Proposal

To: **CGC General Contractors**
Project: **NRH20**
Project Address: **9001 BLVD 26 North Richland Hills, TX 76180**

Change Order Request # 005 REV 1

PROJECT INFORMATION
NRH20 SLIDE REPLACEMENT

MR-2

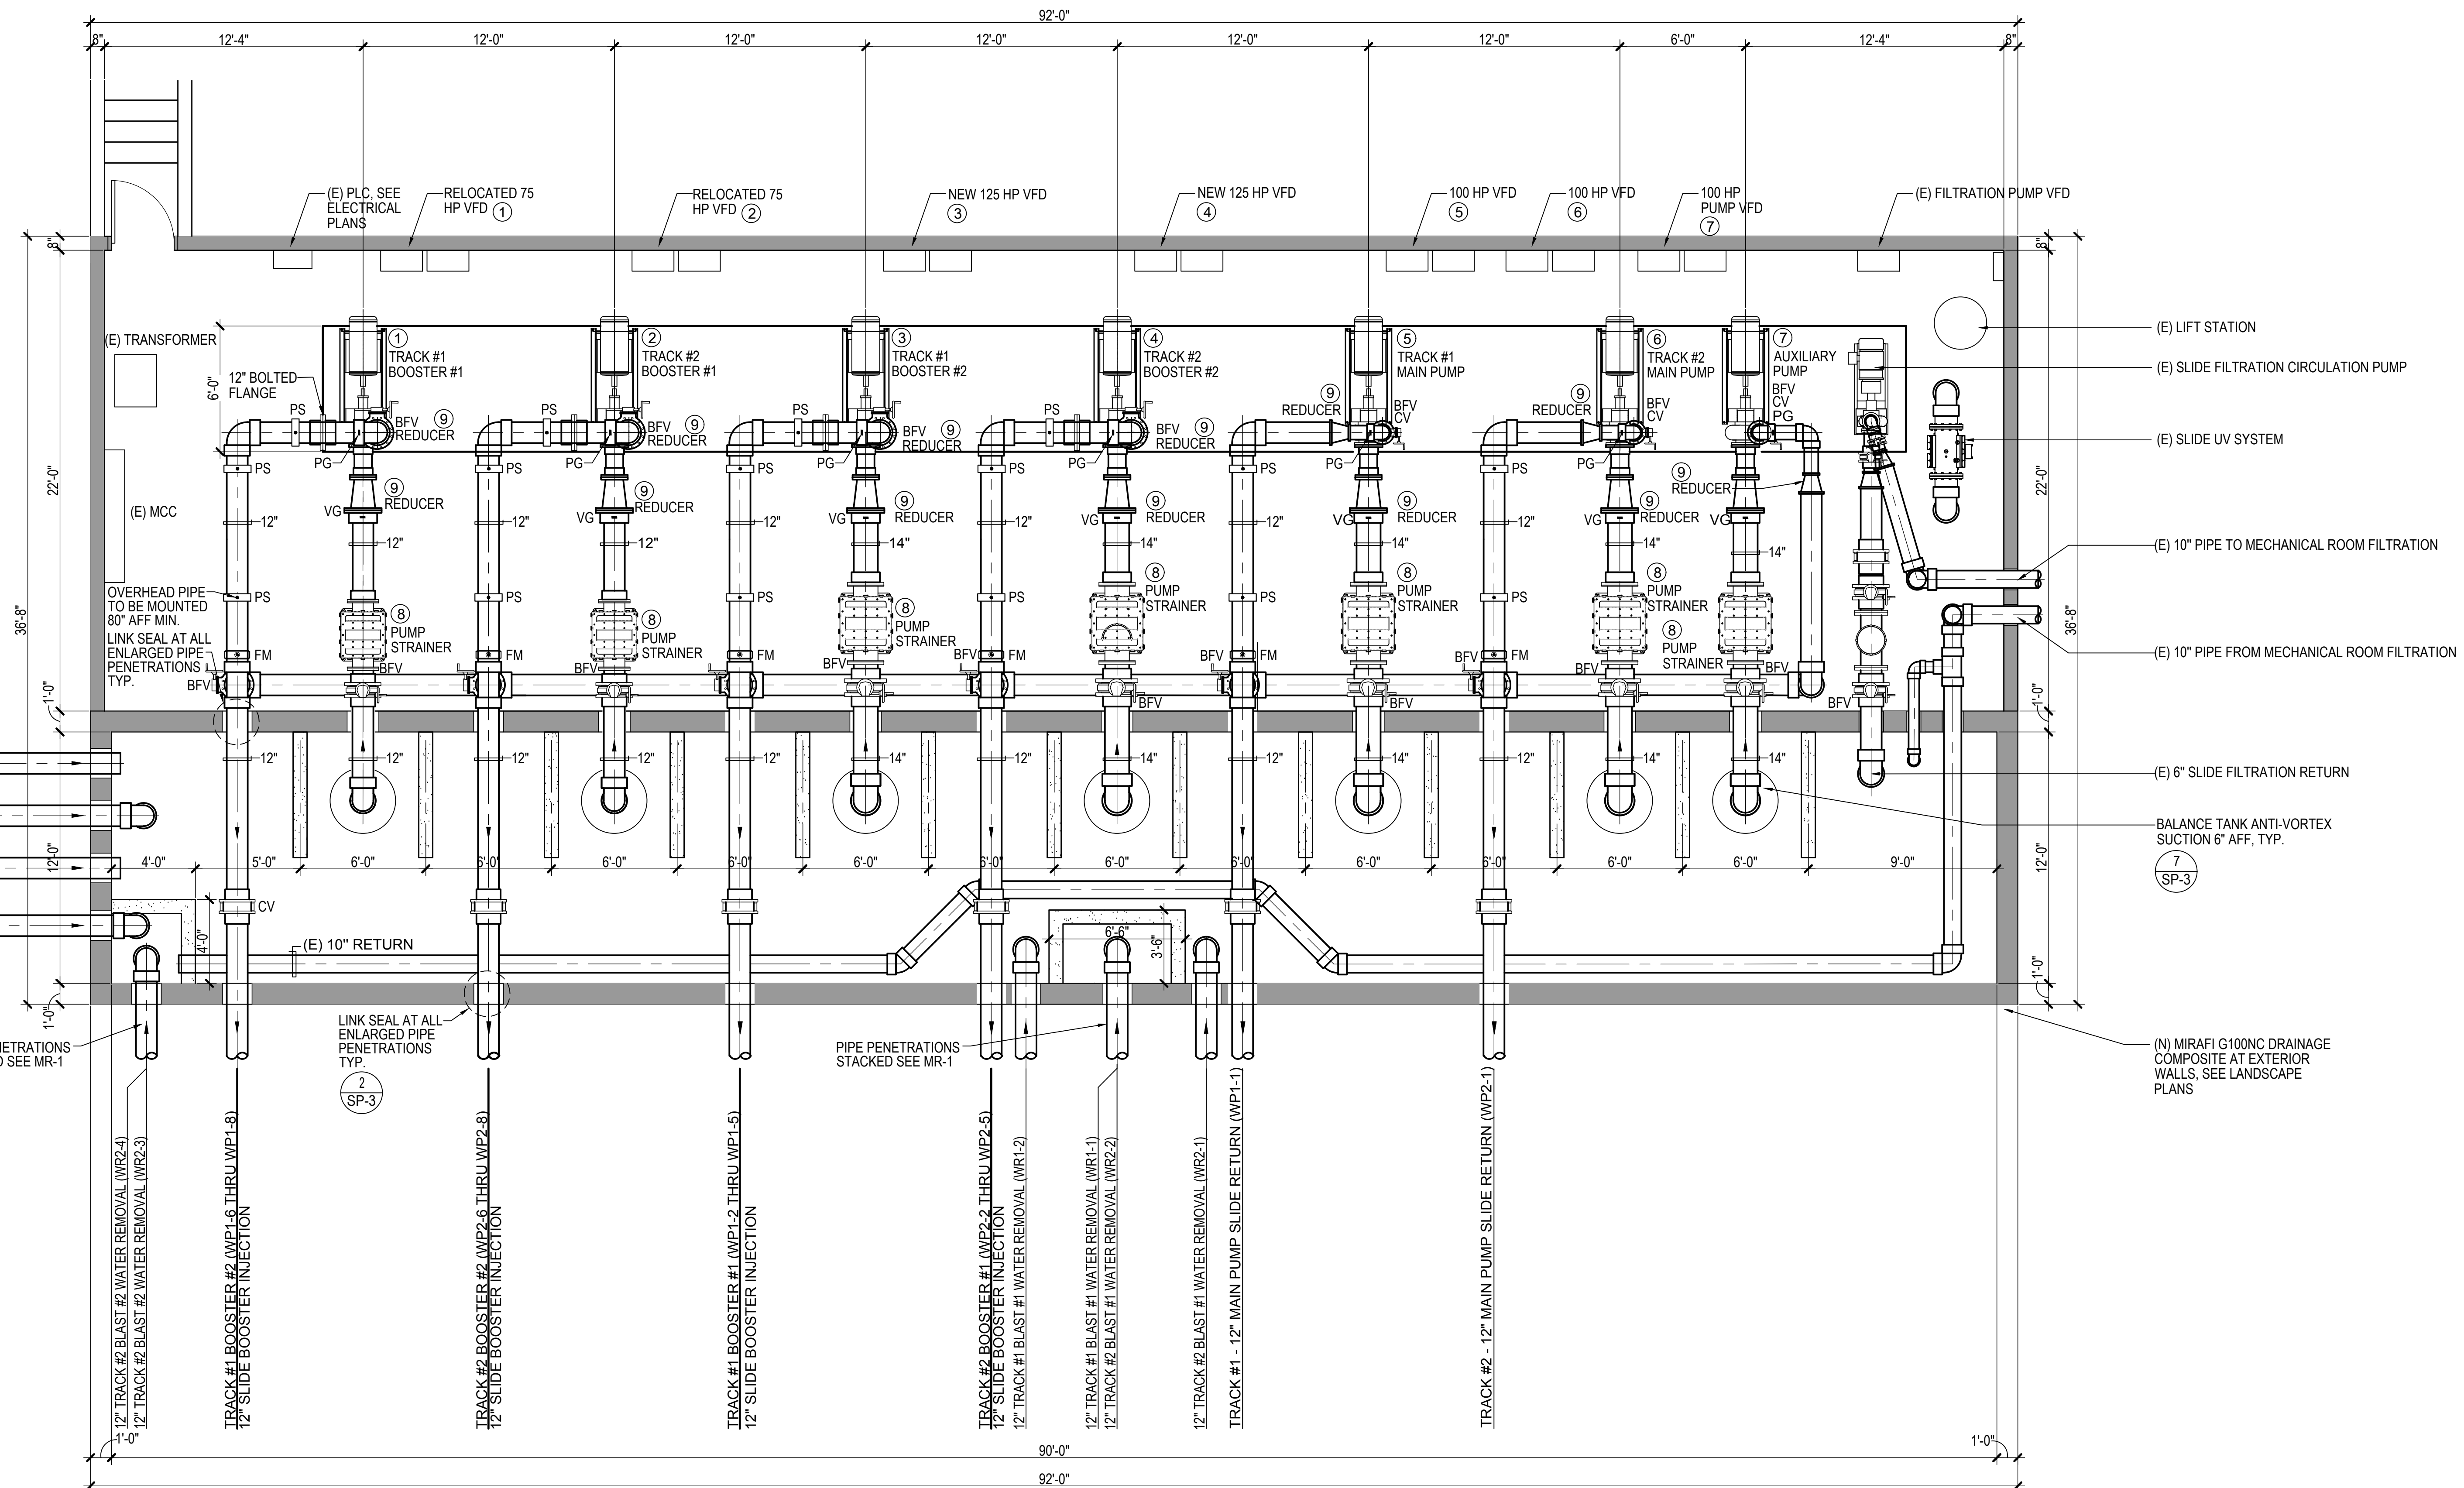
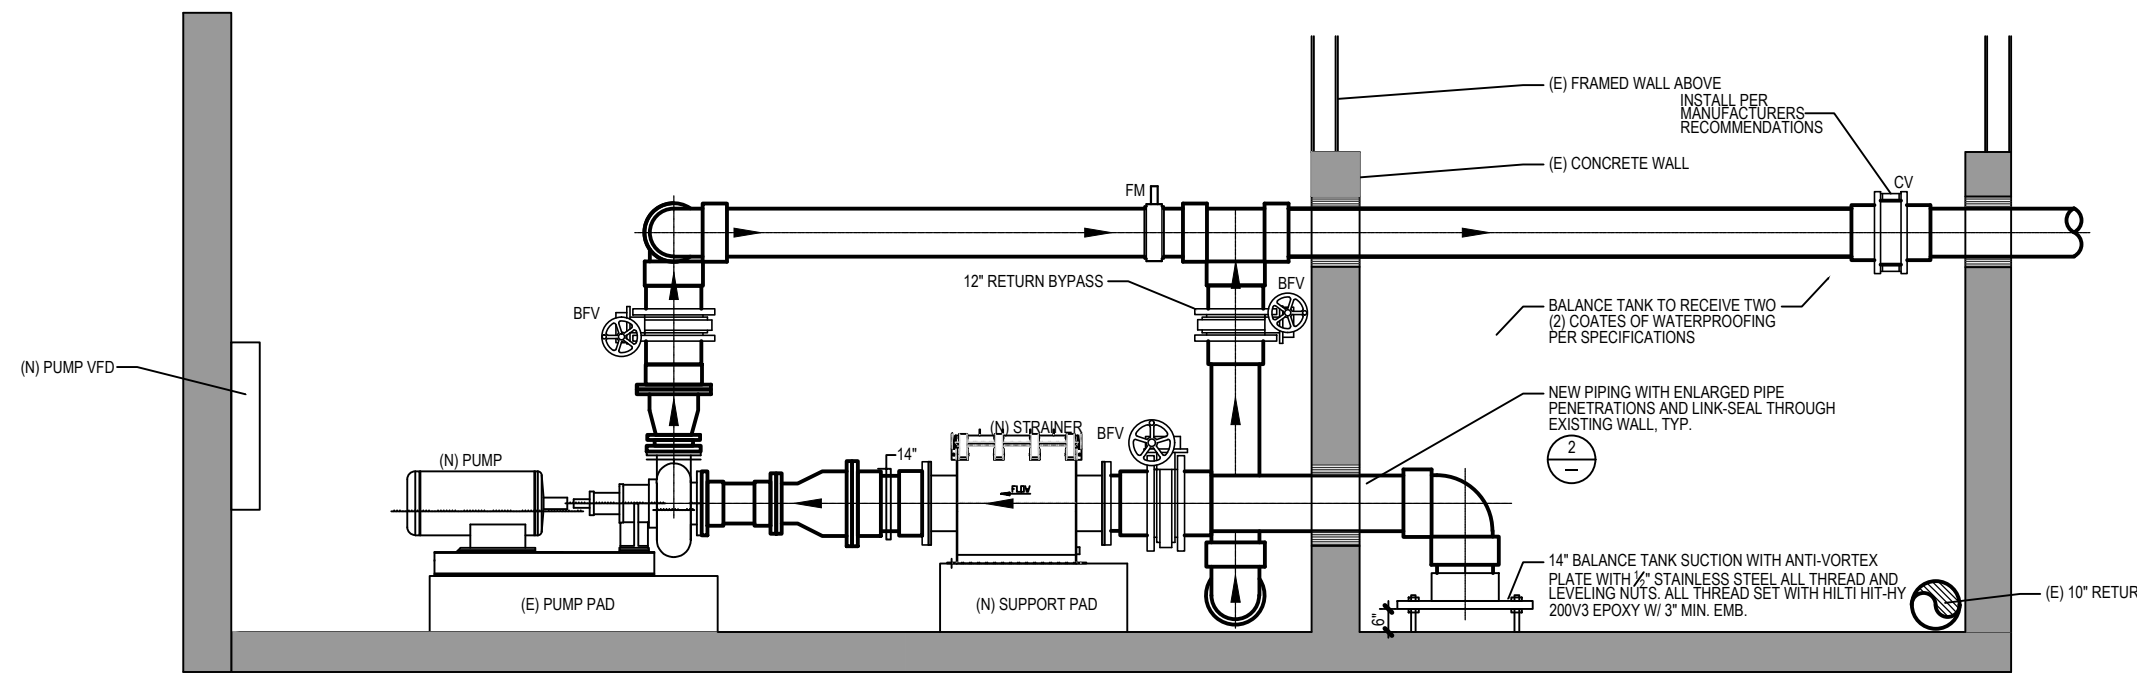
- Install plumbing per revised drawing MR-2 on 4 pumps
 - Relocate 75HP Pump to Track#1 Booster#2
 - Relocate 75HP Pump to Track#2 Booster#2
 - Furnish & Install(F&I) Grundfos 125HP Pump to Track#1 Booster#1

- Furnish & Install Grundfos 125HP Pump to Track#2 Booster#1
 - Check valves should be installed in mechanical space as there is a drain line on the manifold to allow for winterization. Installing the check valves in the baffle tank area as indicated on the plan will require each check valve to be removed for winterization/drainage of the associated discharge line.

- **Titan CV90-DI with NSF rated coating Check valves included in lieu of Flomatic(not manufactured in 12")**
- Rewire Switchgear and pumps as required per revised layout drawing MR-2

- F&I 2 EA 125 HP Variable Frequency Drive(VFD)
 - Relocate 75HP VFDs as indicated on MR-2
 - F&I breakers for 2 EA 125HP Motors
 - F&I new conduit and wire from switchgear to 2 EA 125HP VFDs and 2 EA 75HP VFDs

- F&I new conduit and wire from VFDs mentioned above to corresponding motors
 - 1 day programming of VFDs to parameters provided on MR-2
- Remove (2) 30HP pumps from pump room (location designated by ownership).
